FORWARDING LIC NOS DPR-31 & 41 APPL FOR AMEND: TECH SPEC PROPOSED CHANGE
CONCERNING REVISION TO THE ECCS COOLING PERFORMANCE AS LISTED AND REQUESTING
PROVISIONS OF NRC'S 06/07/78 ORDER BE DELETED... NOTARIZED 08/09/78.

PLANT NAME: TURKEY PT #3
TURKEY PT #4

Re: Turkey Point Units 3 and 4
Docket Nos. 50-250 and 50-251
Proposed Amendment to Facility
Operating Licenses DPR-31 and DPR-41

FIGURE 3.2-3

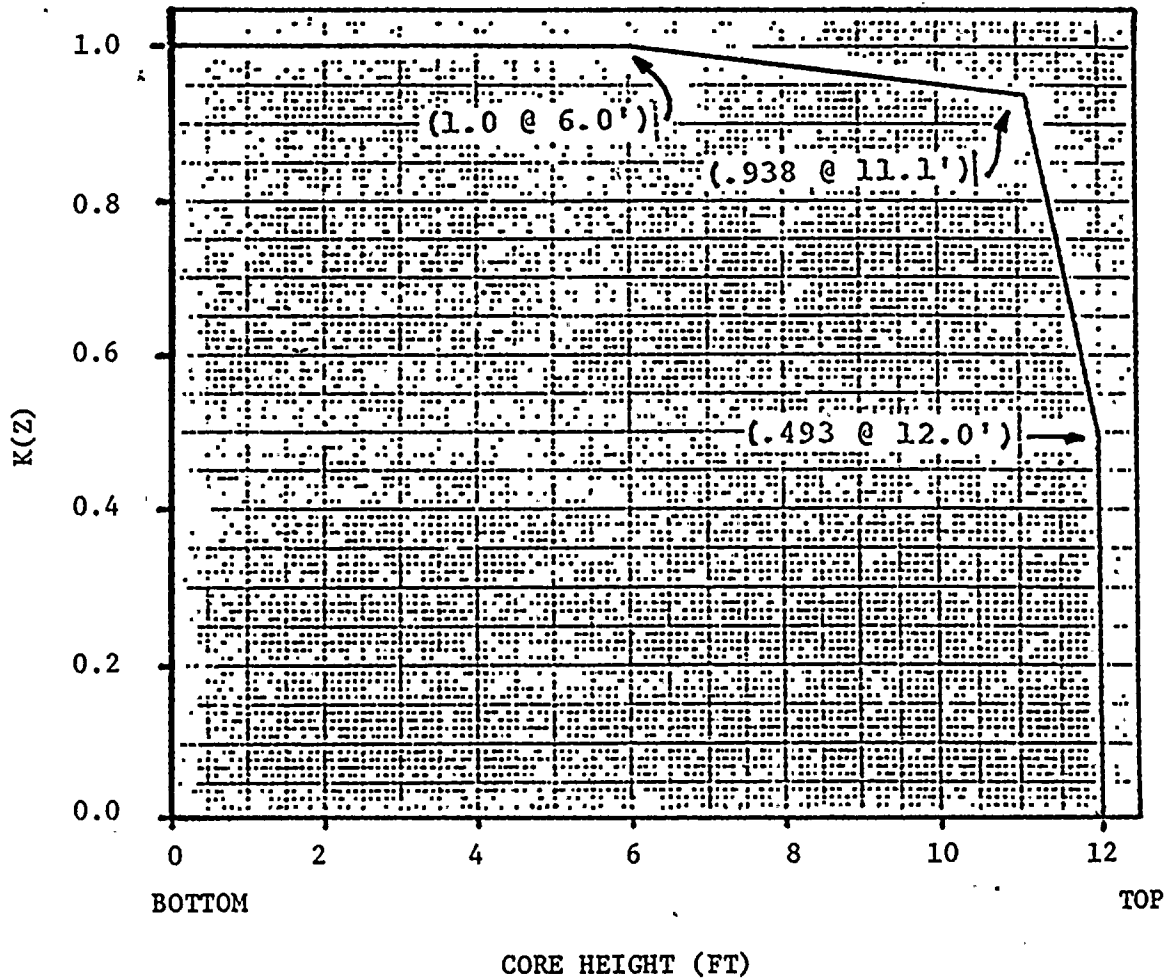
Figures 3.2-3 and 3.2-3a

The current figures are deleted and replaced with a single Figure 3.2-3 (Hot Channel Factor Normalized Operating Envelope) that is valid for an F_Q of 2.03 and steam generator tube plugging $\leq 25\%$.

HOT CHANNEL FACTOR-NORMALIZED
OPERATING ENVELOPE (FOR STEAM
GENERATOR TUBE PLUGGING $\leq 25\%$ and $F_q=2.03$)
